**TOWN OF BROOKFIELD
PLAN COMMISSION MINUTES
May 23, 2023**

TOWN OF BROOKFIELD PLAN COMMISSION ZONING REPORT

RE: **Quest Interiors – Final Approval**
21055 Crossroads Circle BKFT1129999007

Strand Associates, Inc.® (Strand) has finished its review of the construction drawings and Storm Water & Erosion Control Calculations resubmittal for the Quest Interiors Development that were received from Excel Engineering, Inc. (Excel) on May 22, 2023, for conformance with the Town specifications and general engineering practices. Before construction may begin, the contractor shall submit all required permits for the development to the state, Wisconsin Department of Natural Resources, Town, and any other relevant agencies. New drawings, stormwater management plan and calculations, and a letter describing the revisions should be returned to Strand after the following concerns have been addressed. Excel's responses to Strand's original comments are *italicized* and Strand's most recent comments are in **bold**.

CIVIL EXISTING SITE AND DEMOLITION PLAN

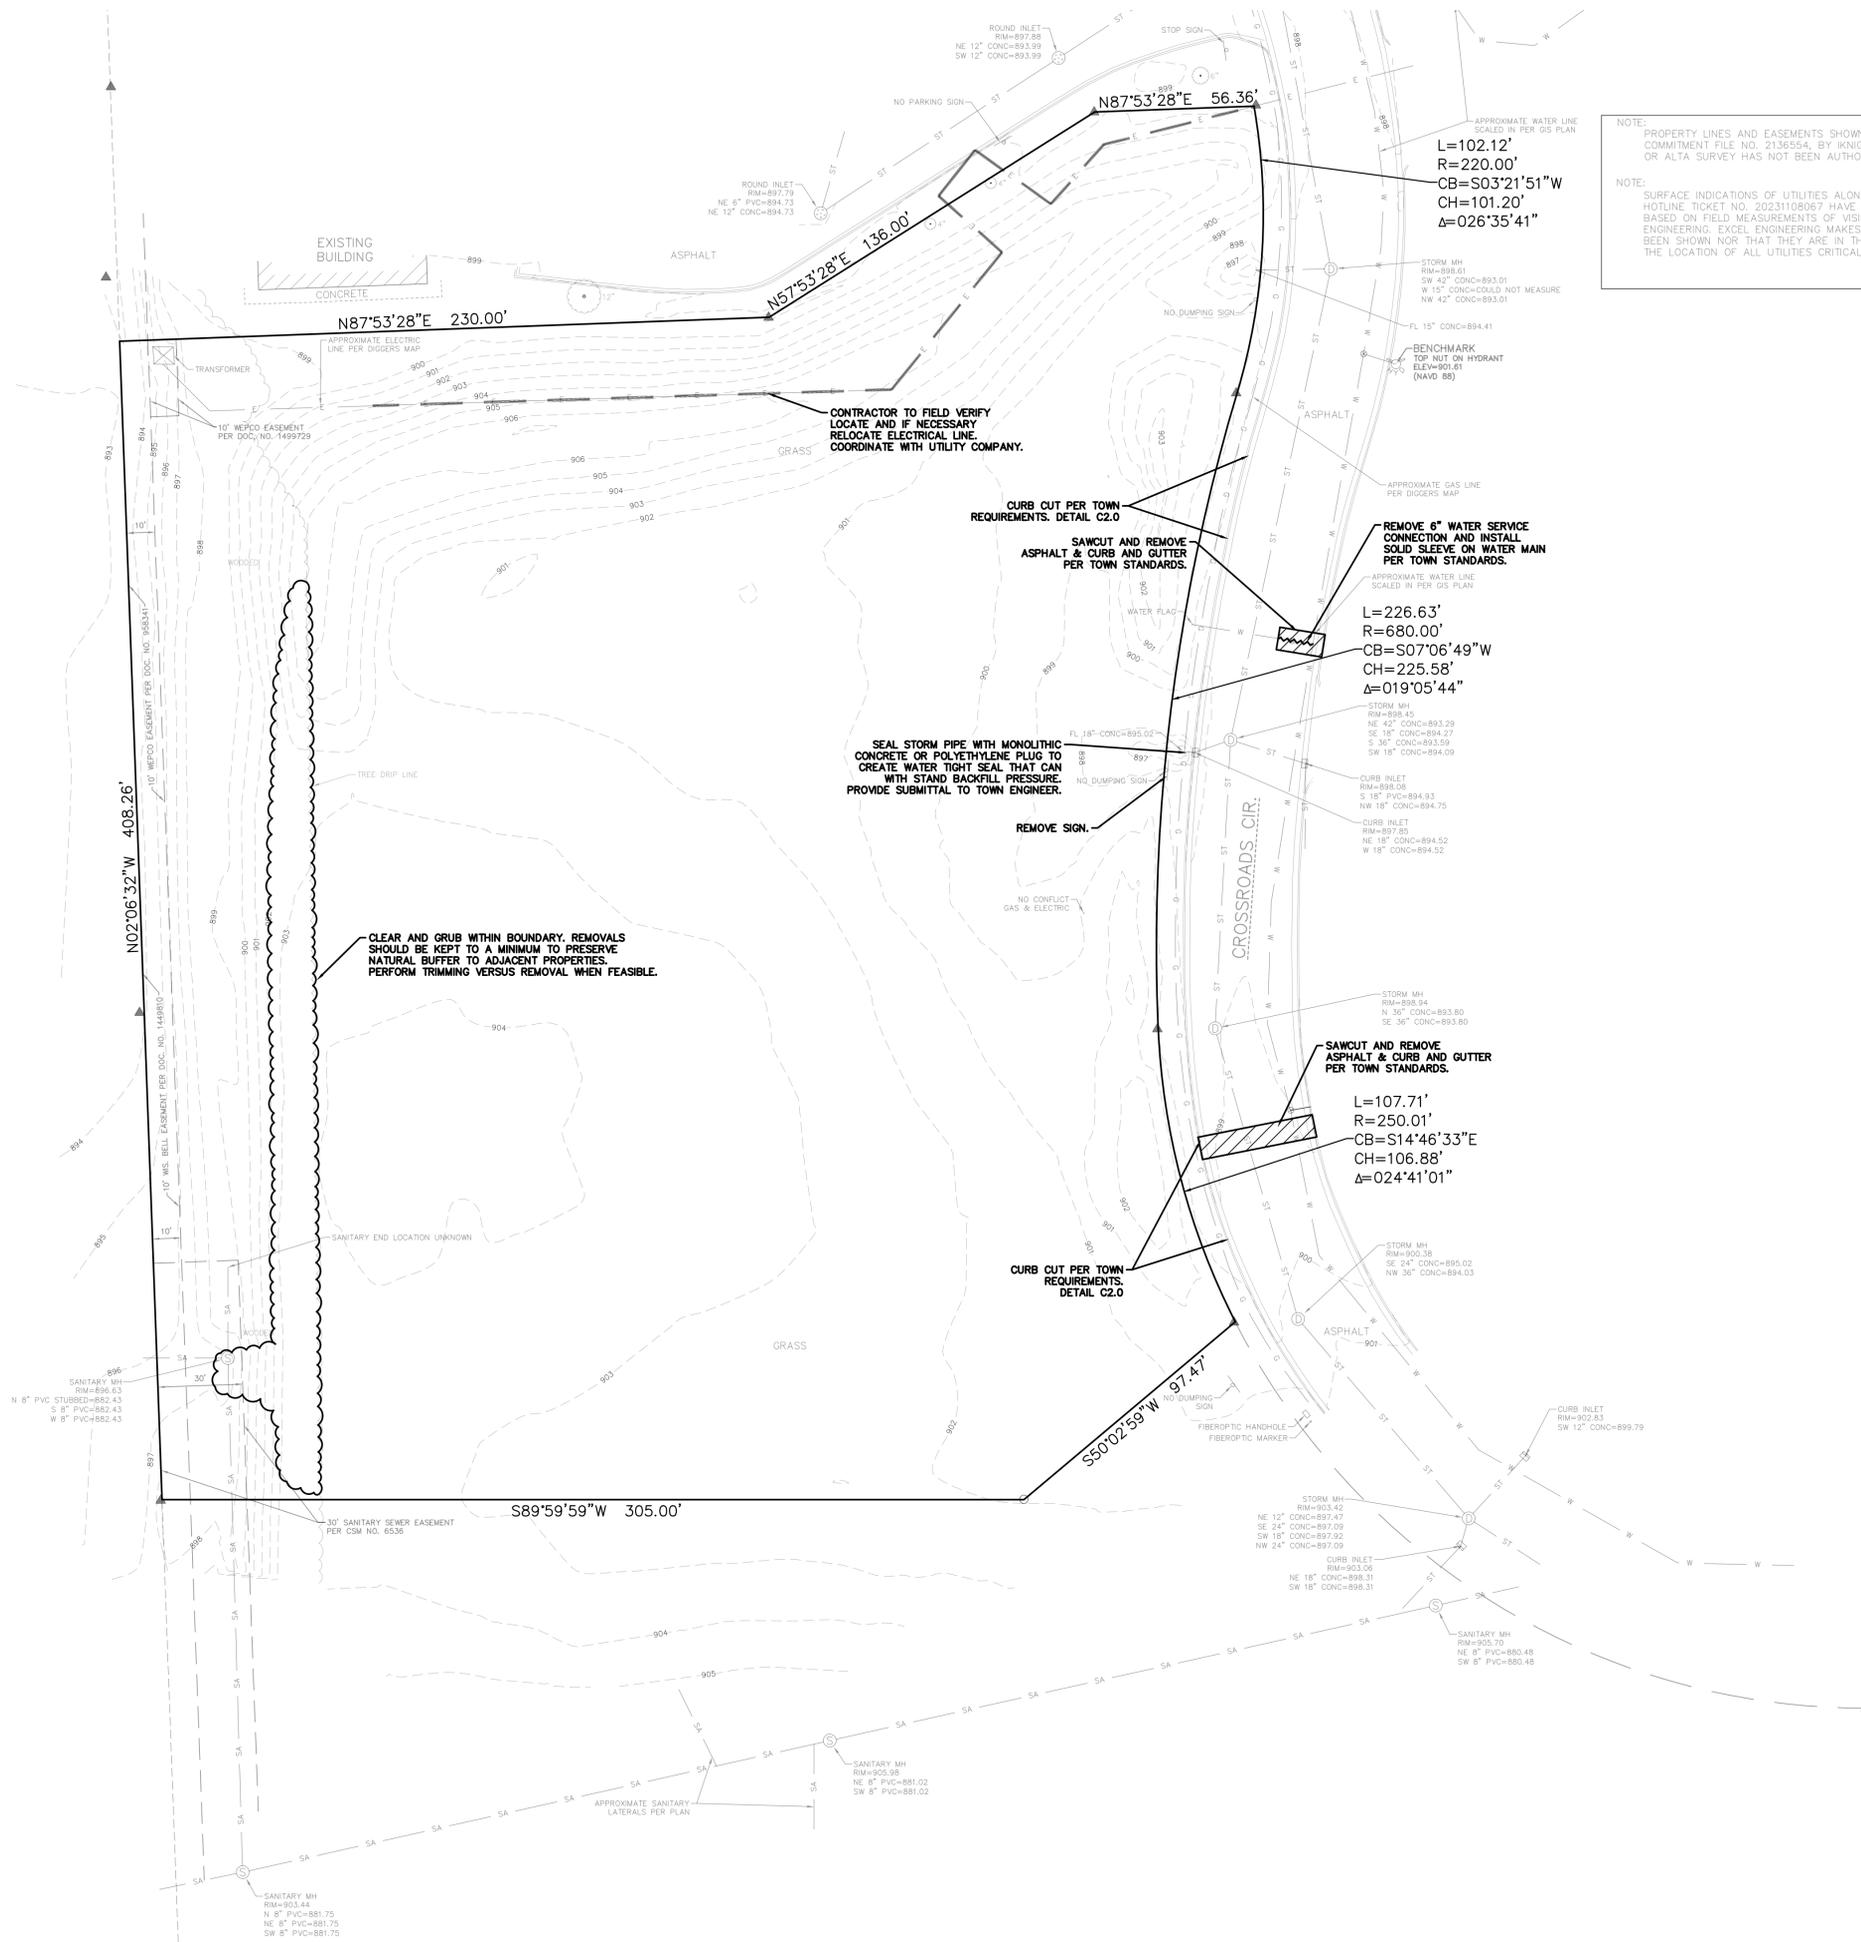
Strand's May 3, 2023, Comment—Specifications or a detail should be provided describing or showing how the storm sewer pipe will be plugged.

Excel's May 22, 2023, Response—Call out note on C1.0 has been revised to provide more directive on plug.

Strand's Current Response—The revised note was reviewed and is acceptable.

CIVIL SITE PLAN

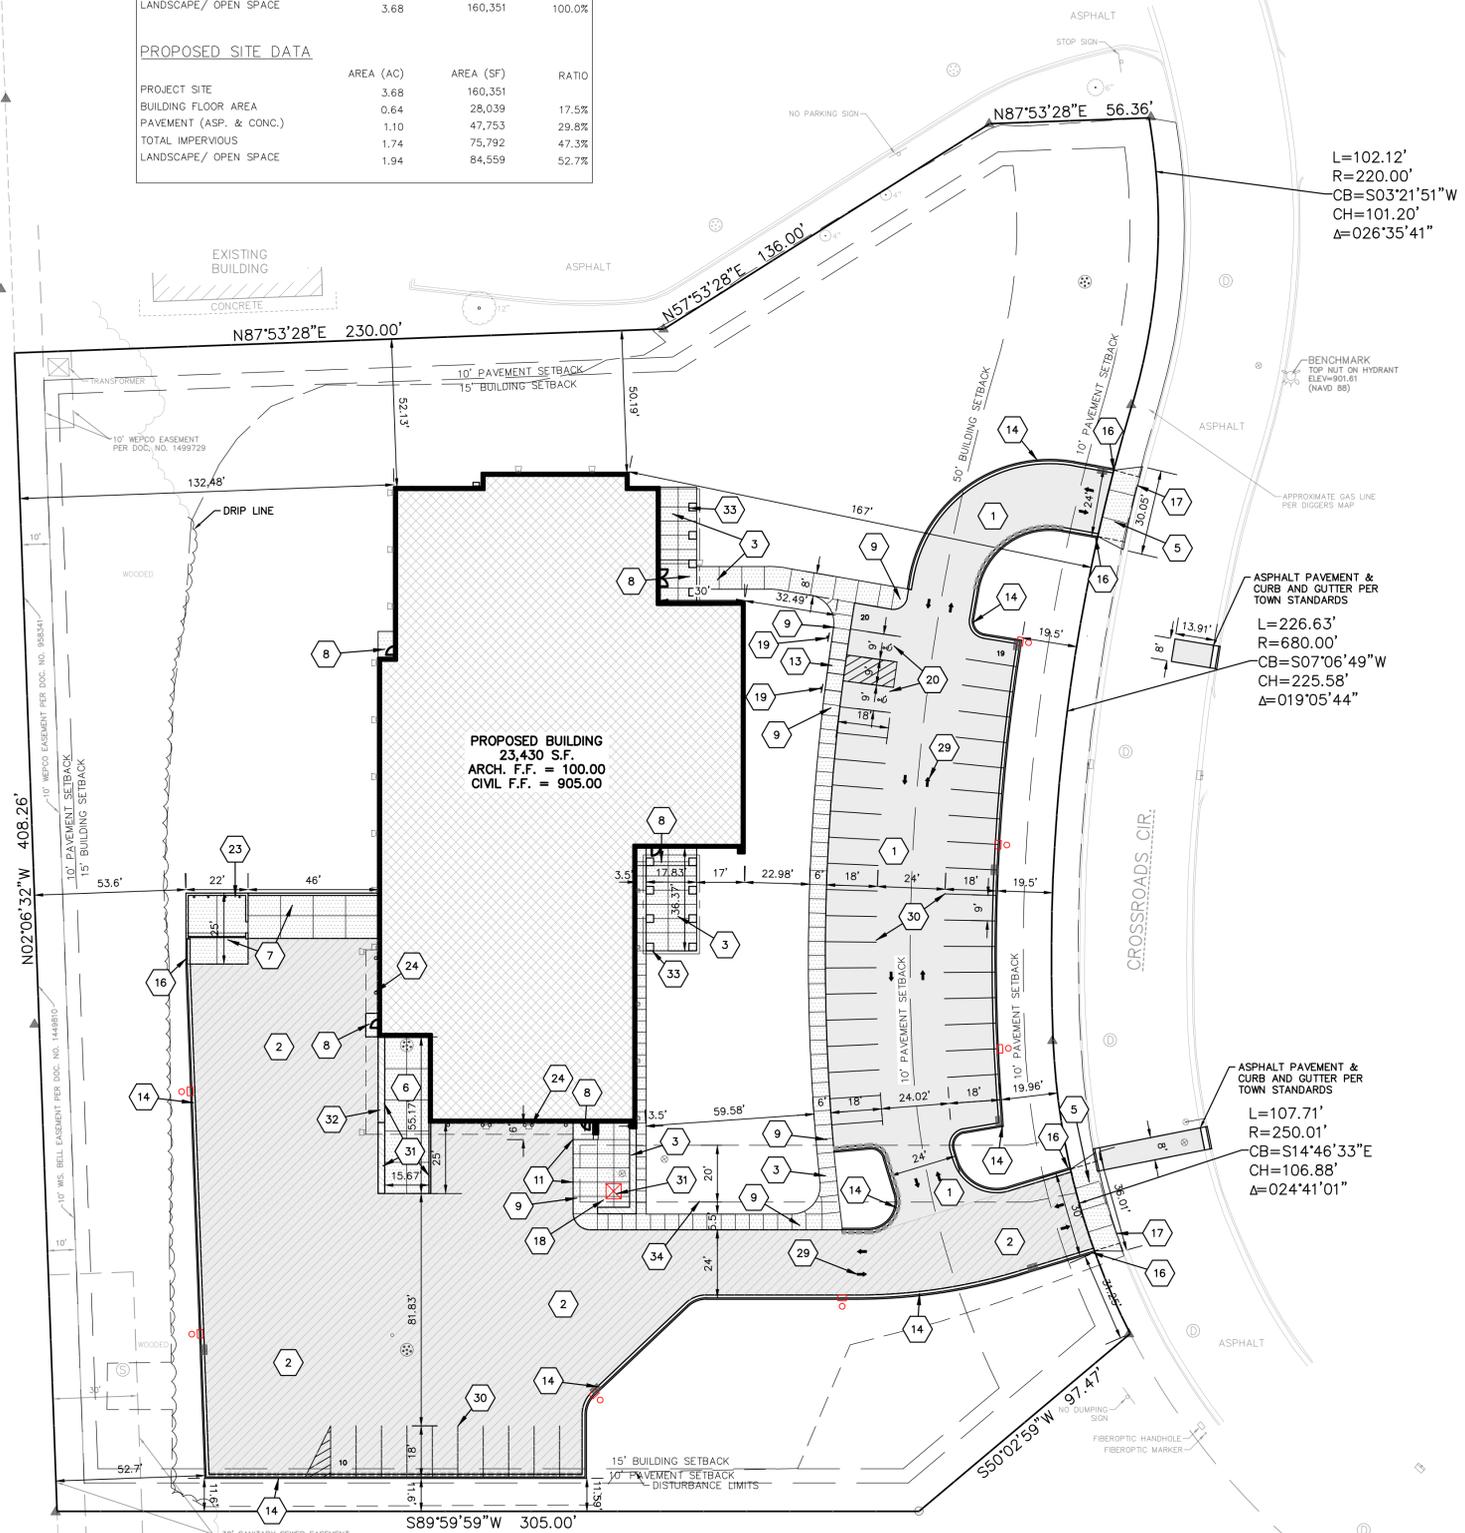
1. Strand’s May 3, 2023, Comment–According to 17.06(3)(c)(4) in the Town ordinance, the minimum dimensions for all parking spaces provided for use by physically disabled shall be 12 feet by 18 feet. It appears that these stalls are 9 feet by 18 feet.

2. Strand’s May 3, 2023, Comment–There is a callout for a Keynote 27 in the plan, but there is no description for “27” in the Keynote legend.

3. Strand’s May 3, 2023, Comment–A turning movement exhibit should be provided to verify the largest vehicle (including any emergency vehicles) that will access the site can perform the required turning movements with the proposed layout.

Excel’s May 22, 2023, Response–The plans shows (2) two 9-foot by 18-foot stalls with a shared 9-foot van accessible aisle. Taking 4.5-feet of the shared stall plus the 9-foot stall provides a 13.5-foot area meeting the code requirements. This will also be discussed at the PC meeting.

Strand’s Current Response–Based on the width of the accessible route, there appears to be adequate space for parking and access and would be able to accommodate cars and vans.

Excel’s May 22, 2023, Response–This keynote has been removed from the plan.

Strand’s Current Response–It was verified the keynote was removed.

Excel’s May 22, 2023, Response–A truck turning exhibit is included in the resubmittal.

Strand’s Current Response–A turning template was provided for a WB-67 interstate semi-trailer and it appears it will be able to access the southern portion of the site and back into the loading dock area. The Town Fire Department should verify whether emergency vehicles, such as a fire truck, should be evaluated for access in the eastern parking lot or northern driveway.

CIVIL GRADING AND EROSION CONTROL PLAN

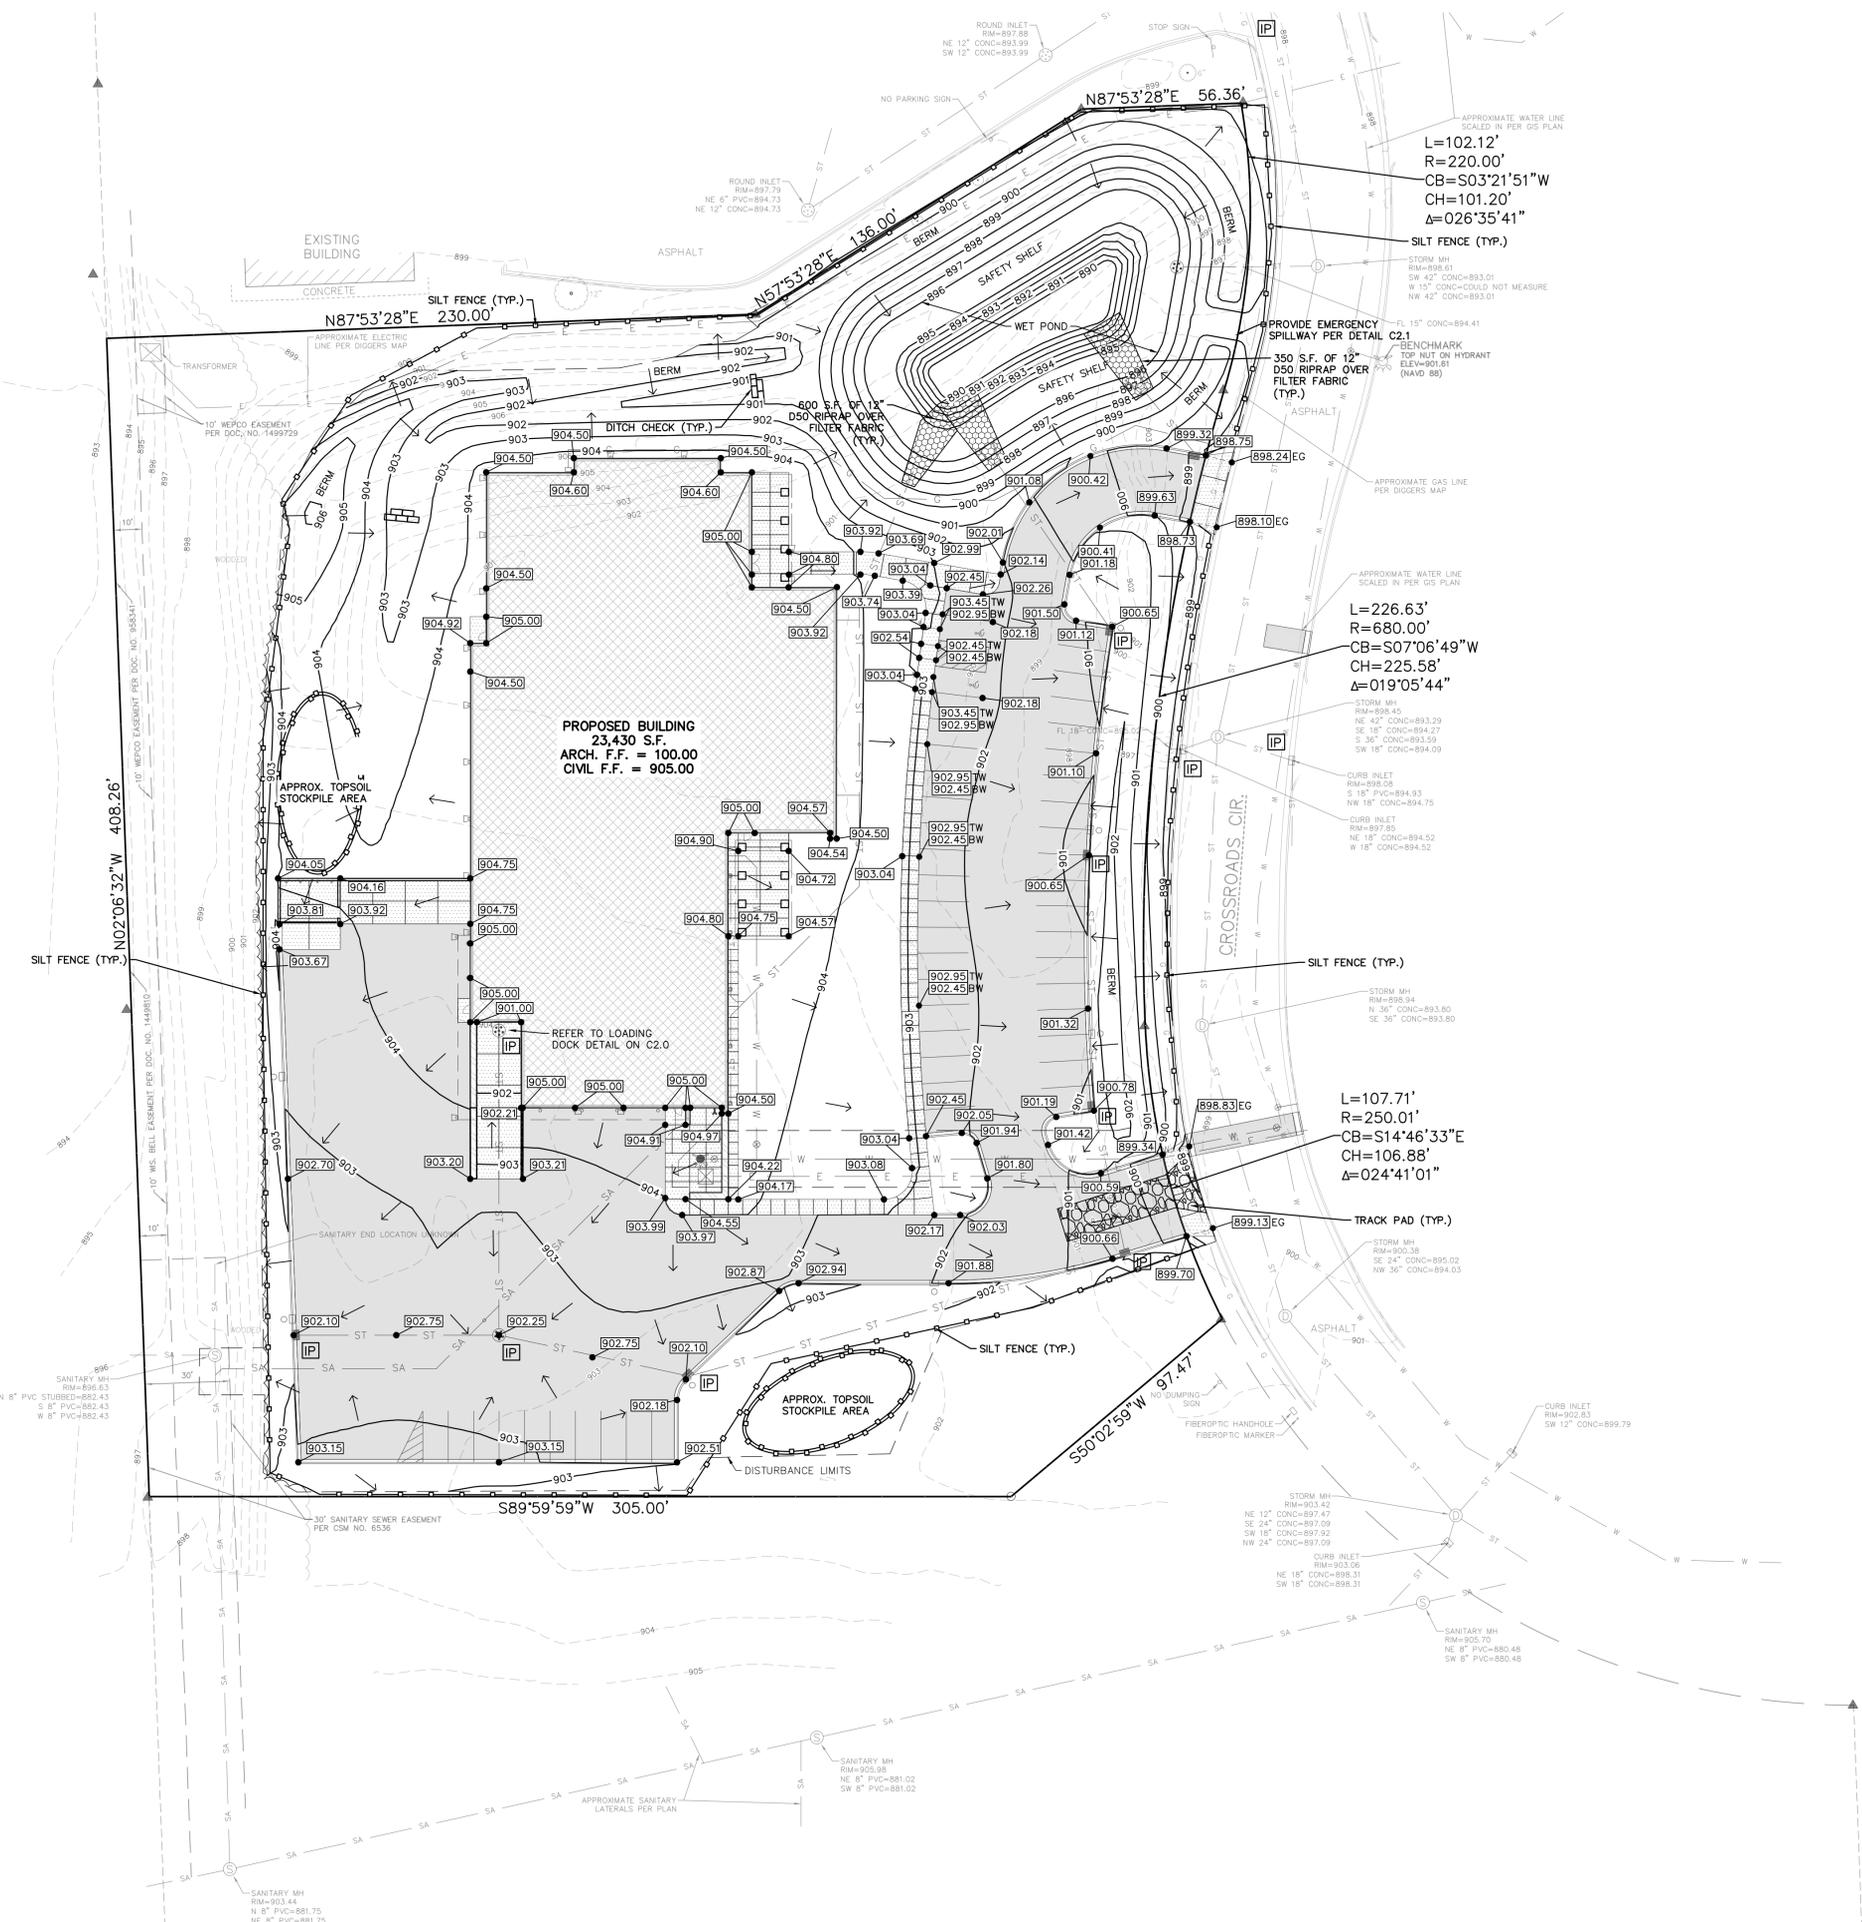
1. Strand’s May 3, 2023, Comment–The anticipated locations of the topsoil stockpiles should be shown on the plan.

2. Strand’s May 3, 2023, Comment–Silt fence should be provided between the two driveway entrances just upstream of the curb line to prevent sediment from washing on to Crossroads Circle.

3. Strand's May 3, 2023, Comment—Safety railings should be provided where the top of wall elevation is more than 30 inches above the adjacent grade according to Section 1013.1 of the Unified Building Code. The top of the retaining wall on the west side of the loading dock ramp. There is a drop of approximately 4 feet from top of the retaining wall on the west side of the loading dock ramp to the bottom of ramp near the building.

4. Strand's May 3, 2023, Comment—The scale bar appears to be incorrect.

Excel’s May 22, 2023, Response–Topsoil stockpile locations have been added to plan sheet C1.2.

Strand’s Current Response–It was verified topsoil stockpile locations are shown on Sheet C1.2 and are in upland areas with two layers of silt fence around the perimeter.

Excel’s May 22, 2023, Response–This has been added to plan sheet C1.2.

Strand’s Current Response–It was verified silt fence was added at this location.

Excel's May 22, 2023, Response—The architectural plans will cover this scope and requirement.

Strand's Current Response—The architectural committee should review the plans to verify requirements are met.

Excel's May 22, 2023, Response—This has been rectified.

Strand's Current Response—Confirmed.
